## **APPENDIX F**

### **CONCURRENCE POINTS AND RECORDS OF MEETINGS SINCE PUBLICATION OF THE 2015 DEIS**

RE: **Section 404/NEPA Merger Process – Concurrence Meeting: CP 3  
NCDOT STIP Project I-2513 (I-26 Connector)**

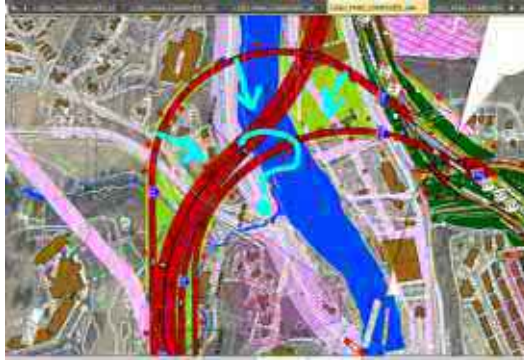
- Comment 34: Clarification of the City’s request is shown below on the public hearing map for Alternative 3, but is requested to be considered for all section B alternatives, depending on which alternative is selected as the LEDPA. It was clarified that the City of Asheville was requesting NCDOT daylight Smith Mill Creek that is currently flowing under the existing Patton Avenue, which may be eradicated upon construction of the LEDPA.
